MARICOPA COUNTY
Department of Transportation

Date: May 21, 2014 Revised 2014-08-14
To: MAG Specifications and Details Committee
From: Robert Herz, MCDOT Representative
Subject: Delete the use of Asbestos-Cement Pipe in Valve Box Installations **Case 14-11**

PURPOSE: Delete the use of Asbestos-Cement Pipe (ACP) in new Valve Box Installations.

DETAIL NO.
391-1

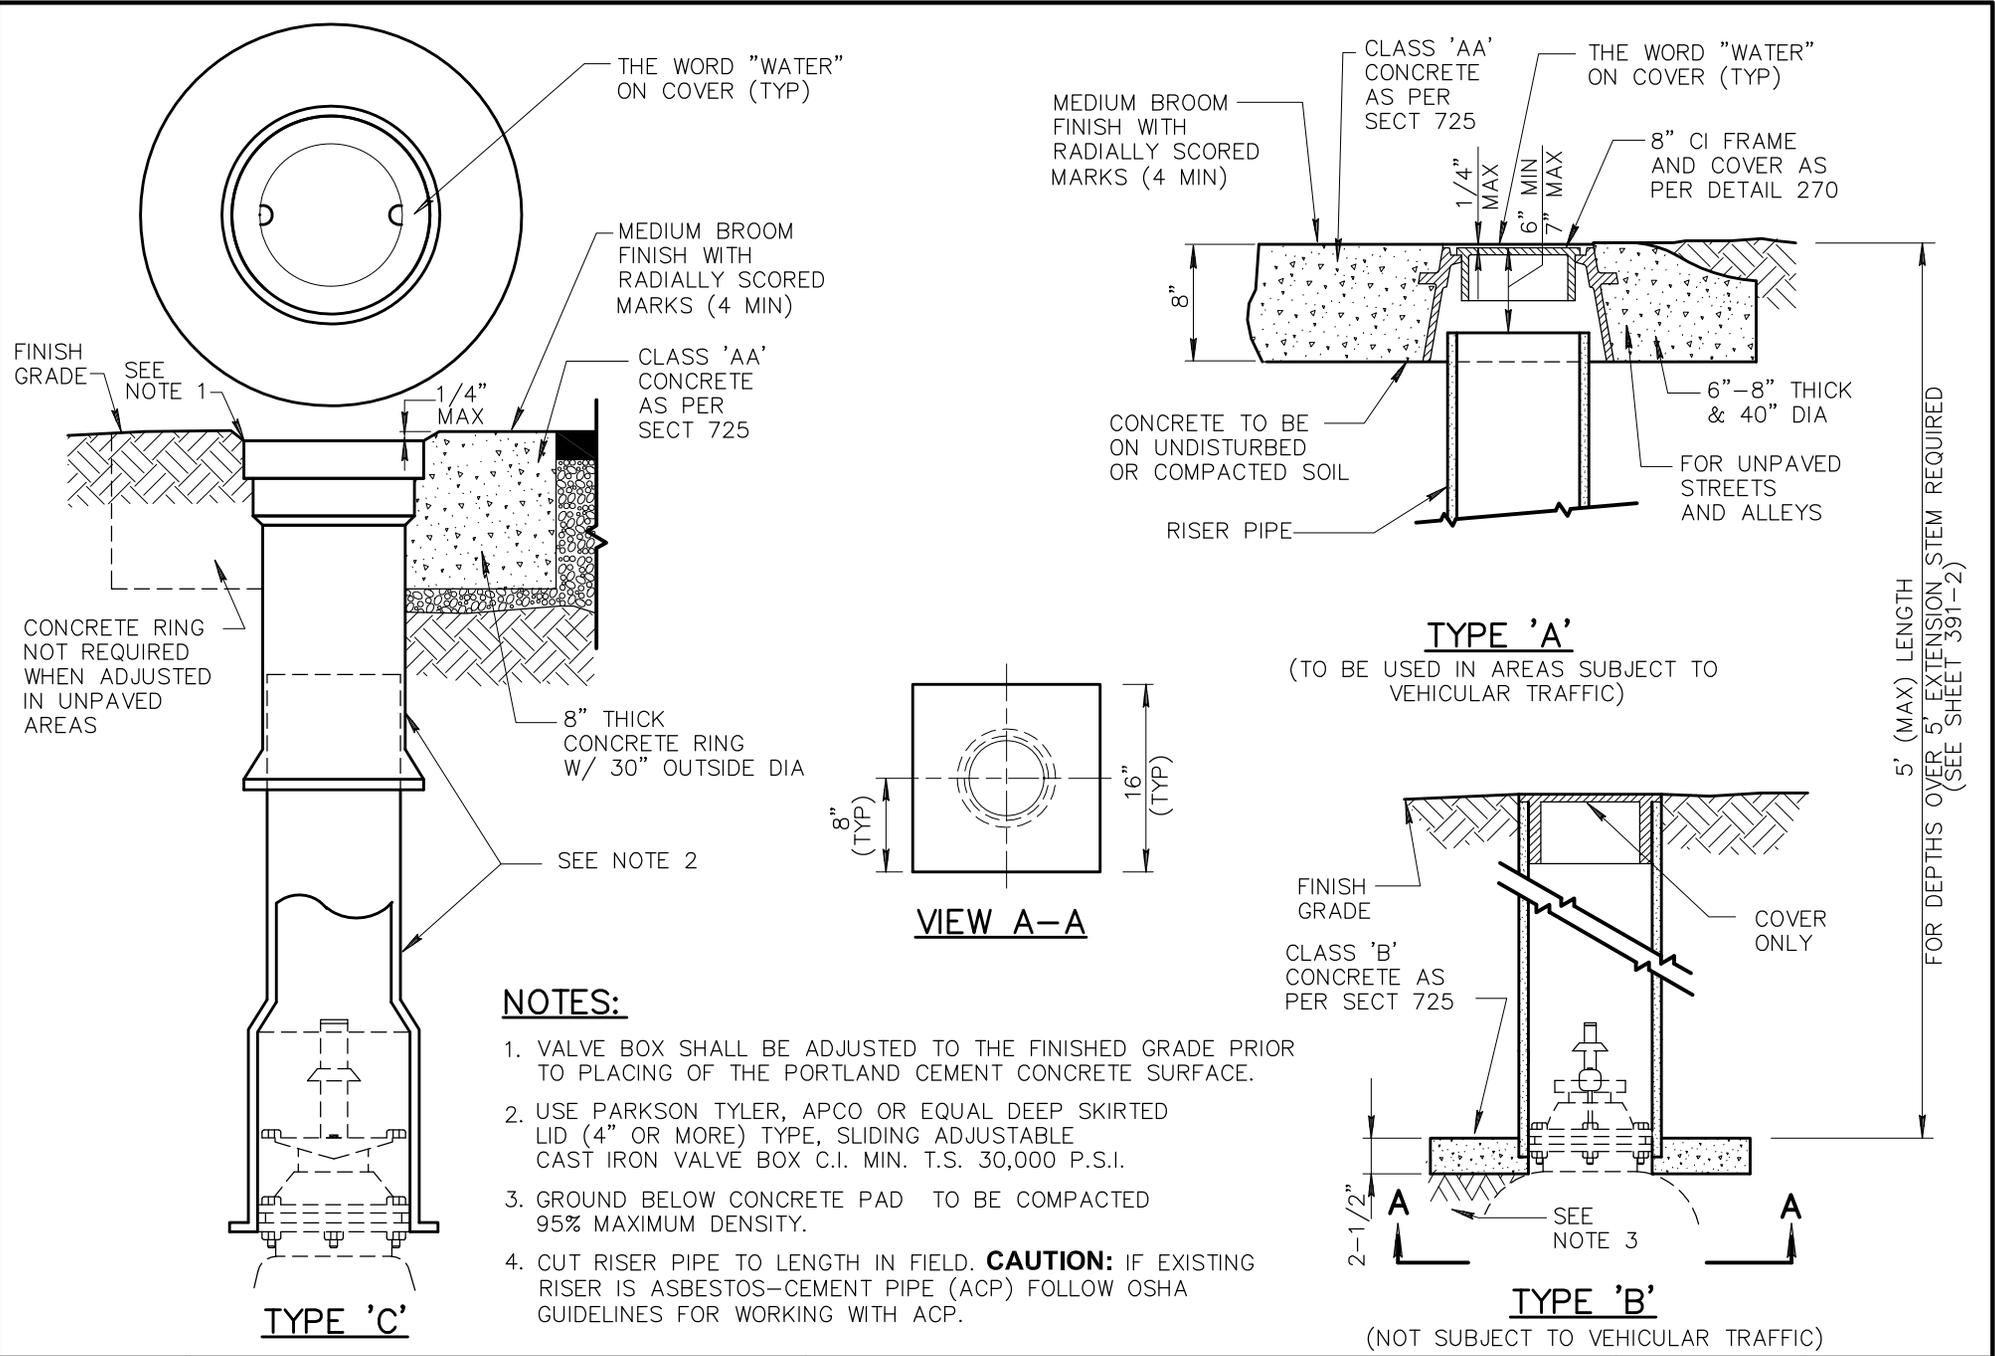
Detail 391-1 Added Note 4: Cut riser pipe to length in field. Caution: If existing riser is asbestos-cement pipe (ACP) follow OSHA guidelines for working with ACP.

DETAIL NO.
391-1

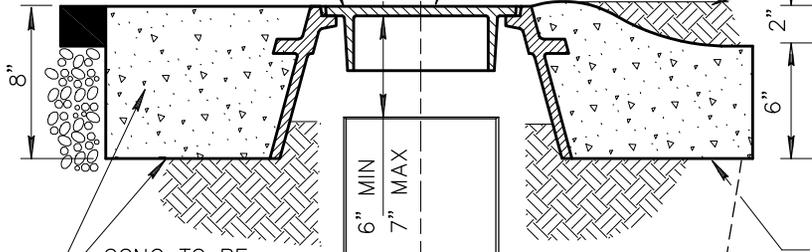
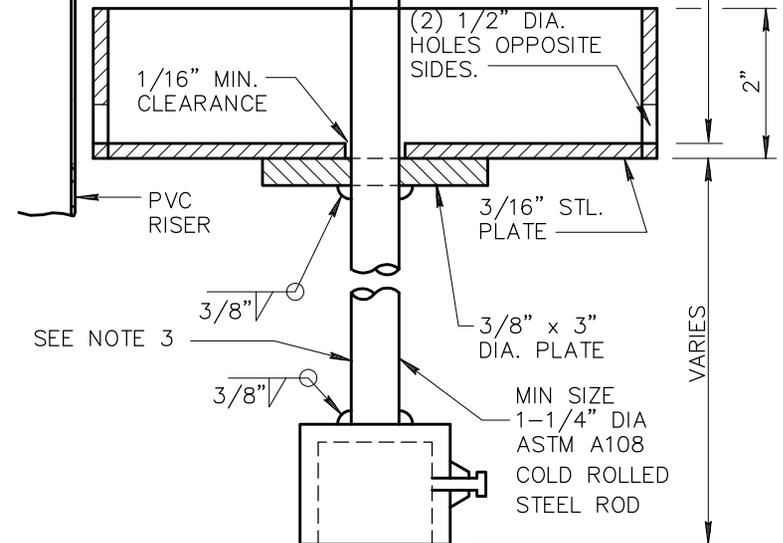
Detail 391-2, Revised the first sentence of Note 2 to read: If two or more sections of pipe are used to make the valve box riser, they shall be coupled or bonded to form debris-tight joints.

DETAIL NO.
391-2

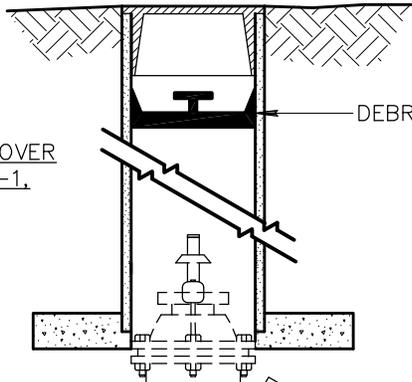
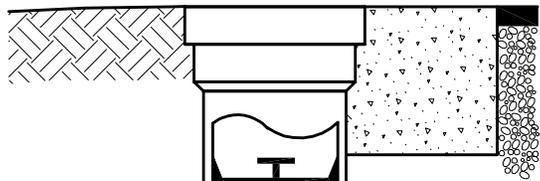
Detail 392: Deleted from the end of note 1 the following: "Once installed the cap must withstand, without slippage, a minimum vertical force of 50 pounds at a loading rate of 1 inch/minute."
